CHANGE/ERRATA INFORMATION

ISSUE NO: 2

6/83

Title: 9000A-Z80 Interface Pod
Print Date: June 1981
Rev. and Date: ---

Figure 1.

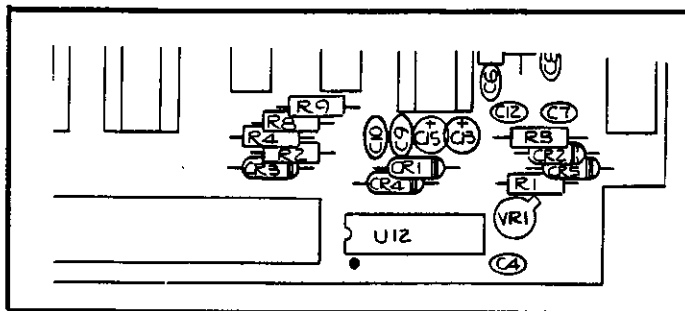
On page 6-11/6-12, Figure 6-3, make the additions listed above to the A12 reference designator drawing as shown in Figure 1.

Figure 2.

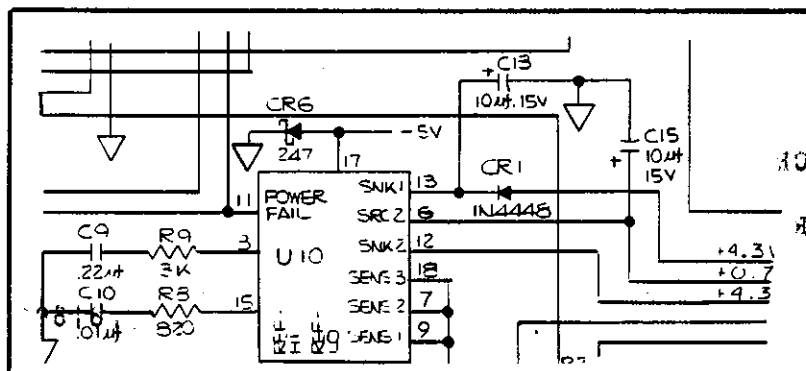
On pages 7-4 and 7-5/7-6, Figure 7-2, change the A12 schematic drawing as shown in Figure 2, and change the value of R4,

FROM: 12k
TO: 1.2k

Figure 3.

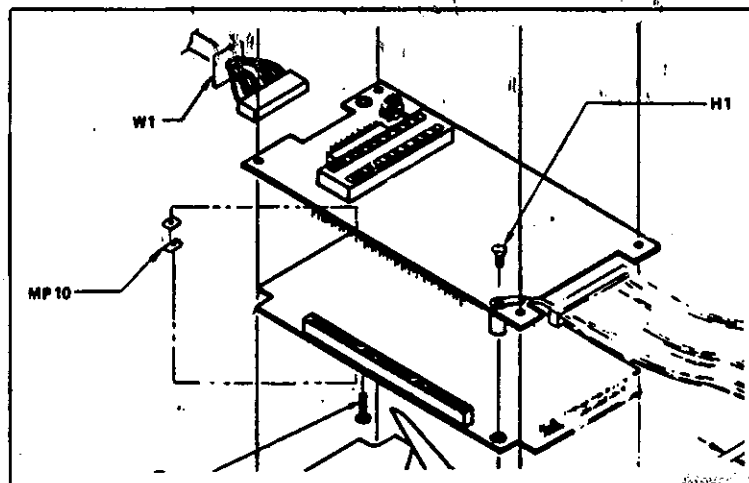
On page 6-4, Figure 6-1, add H1 and MP10 as shown in Figure 3.

On page 6-4, Figure 6-1, change W1 as shown in Figure 3.
